SECOND PROJECT AMENDMENT REPORT

Prepared for Tahmoor Coal Pty Ltd
August 2020

Tahmoor South Project

Second Amendment Report and Response to Submissions

Figure 7.2 Potential biodiversity stewardship sites – Site 1

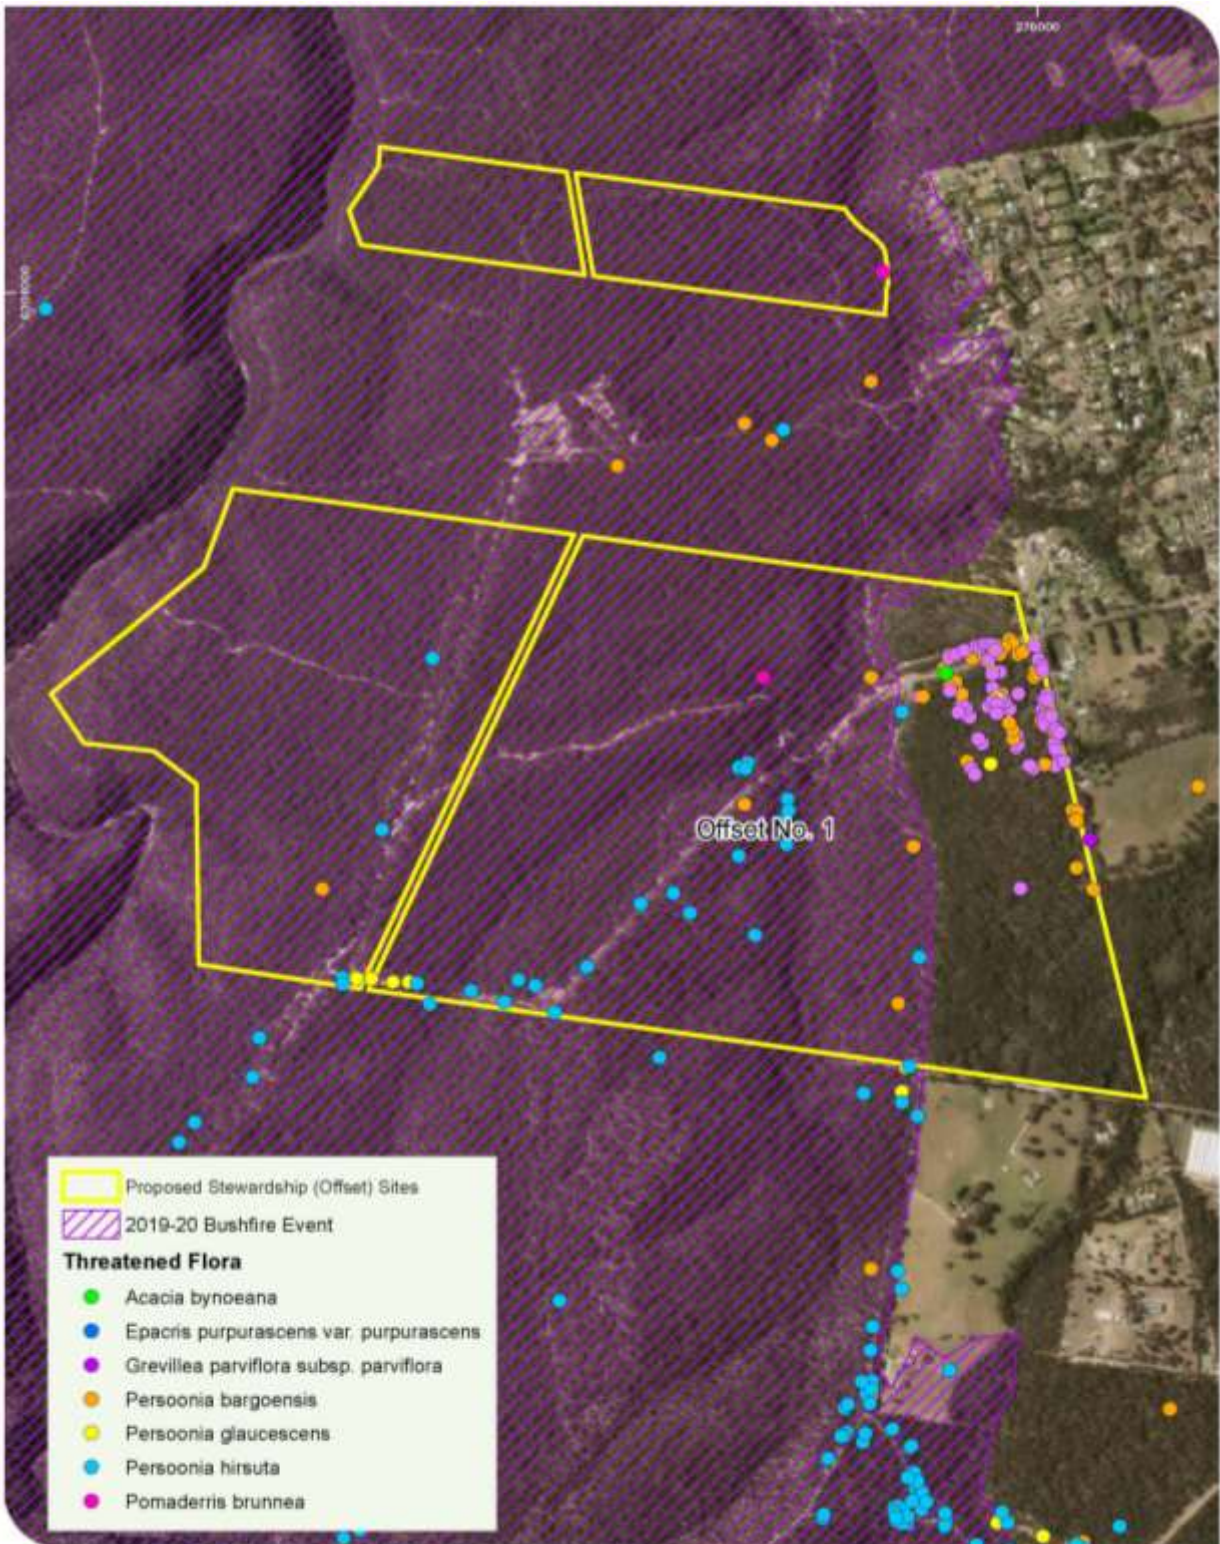
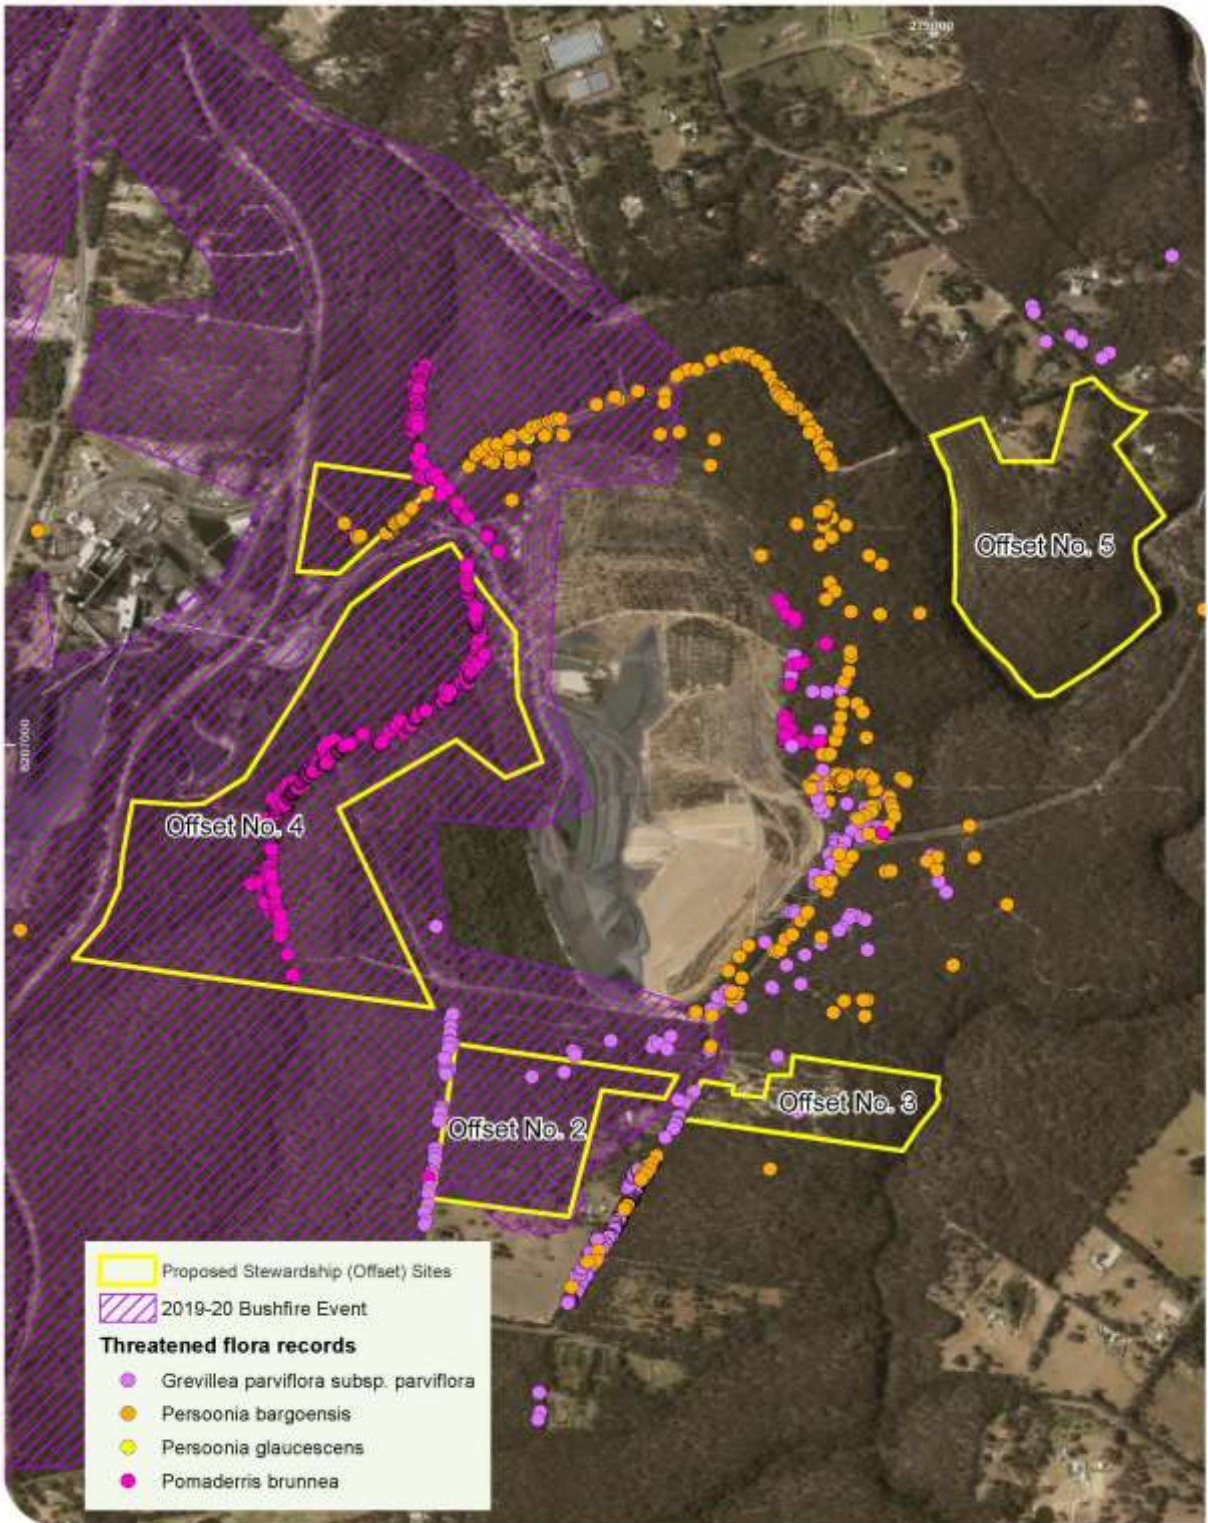
Hollow bearing trees are shown on Figure 17 in the Amended BAR. It is not clear which trees can be retained, and which will be cleared, particularly in the vent shaft areas.

A total of seven hollow-bearing trees would be removed for the Project. The location of the hollow-bearing trees in respect to the area of direct impact, are shown on Figure 7.1.

Each of the BSSs are shown on Figure 7.2 and Figure 7.3 in relation to the 2019/2020 bushfire event.

The population of *Persoonia bargoensis* and the core population of *Grevillea parviflora* subsp. *Parviflora* that occur on the eastern edge of BSS 1 were not impacted by the recent bushfire event. The location of the threatened flora is provided in Figure 7.2.

Figure 7.4 Modelled and Recorded Flow Duration Curves - Dog Trap Creek Downstream (GS 300063)

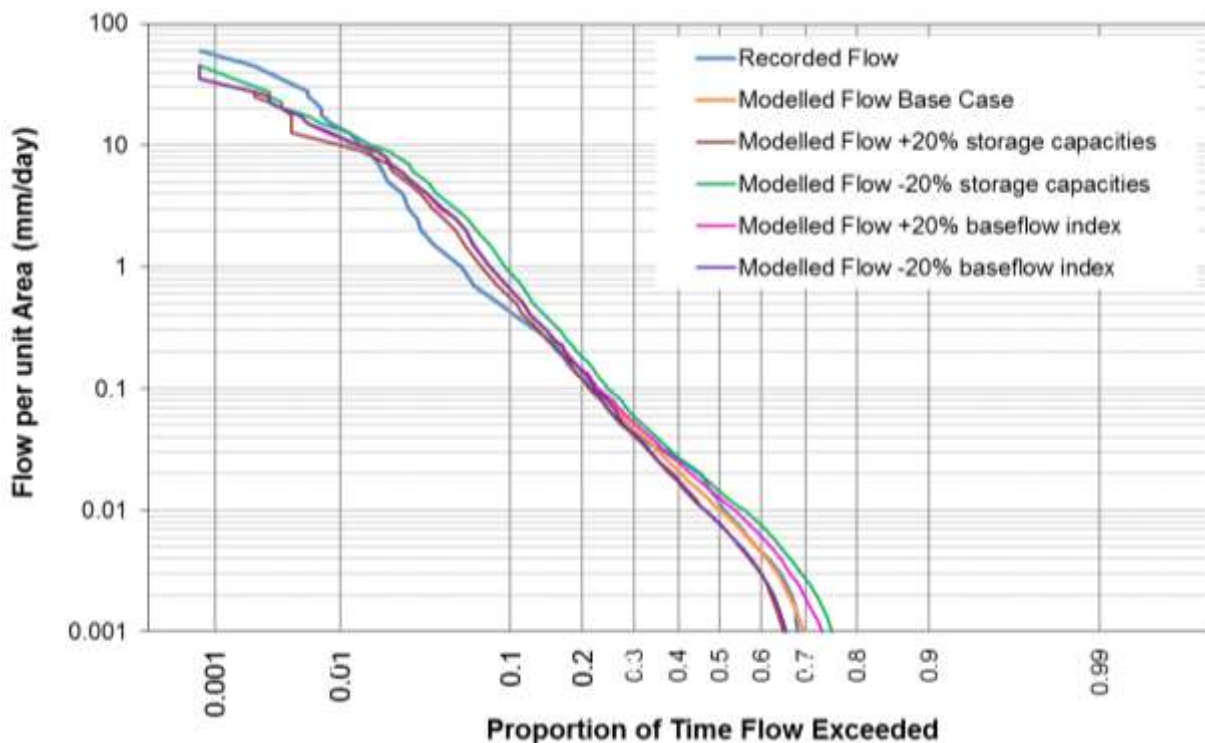
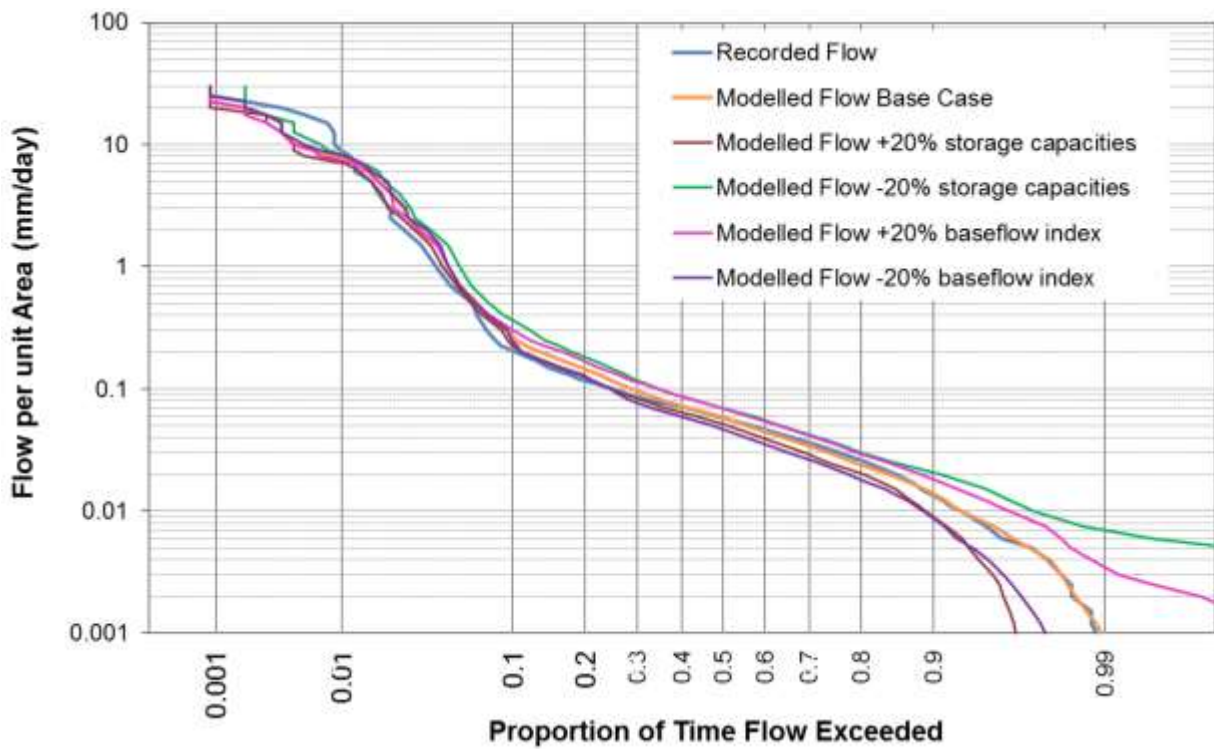
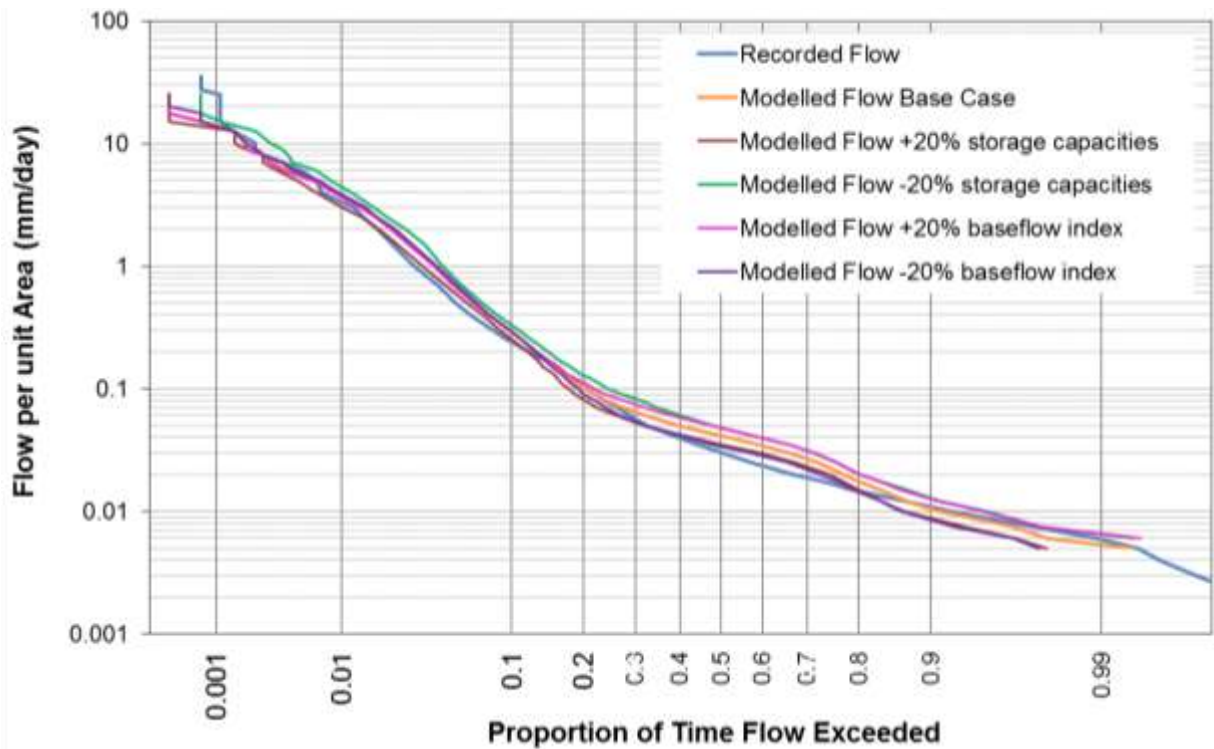
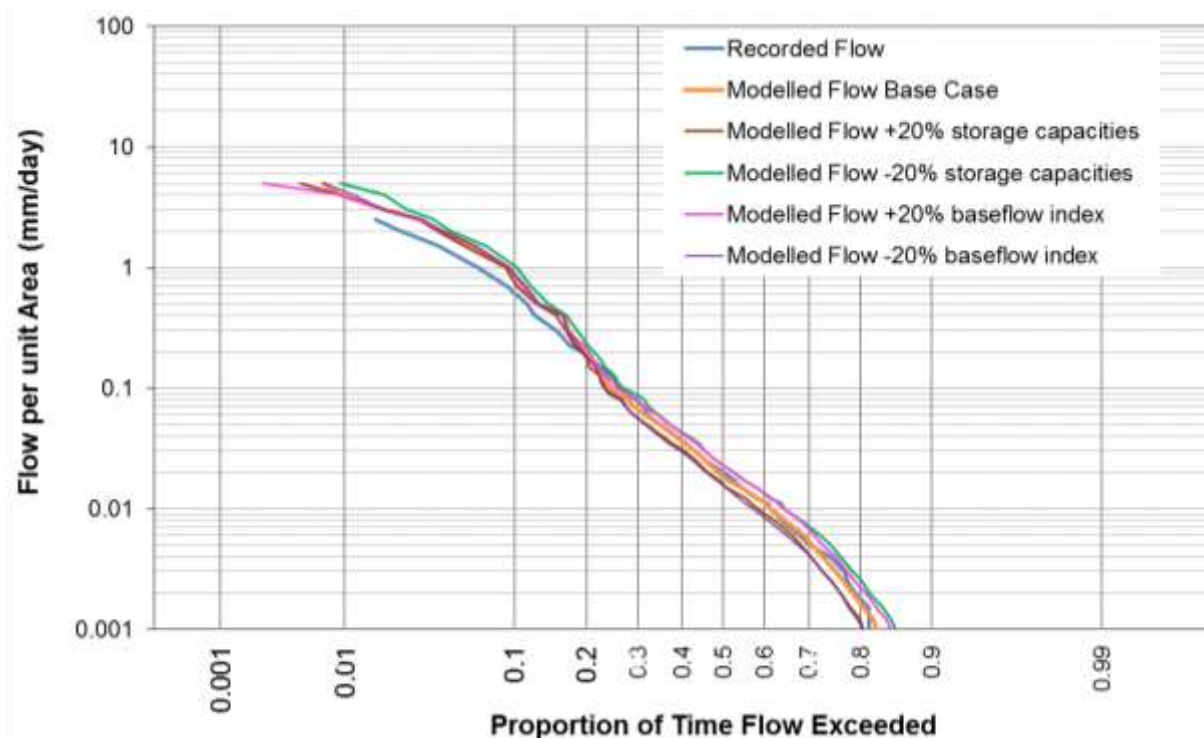
Model calibration is described in Appendix J of the EIS, with goodness-of-fit metrics for the first three streams presented in Section 5.4 of the SWBS. These are described as varying between very good, satisfactory and acceptable, with coefficients of determination on monthly flows of between 0.72 and 0.77. For Redbank Creek the coefficient of determination was 0.94. These metrics do not support the assertion that the models are poorly calibrated.

The veracity of the models is further demonstrated by undertaking sensitivity analyses - where key model parameters (surface store capacities and baseflow index) have been varied by +/-20 per cent. The corresponding effect on the flow duration curves for the four stations for their respective periods of calibration are shown in Figure 7.4 to Figure 7.7.

The above flow duration curves indicate that model results are not highly sensitive to significant changes in the key model parameters. This illustrates the robustness of the AWBM and further supports the results reached from the use of these catchment yield models.
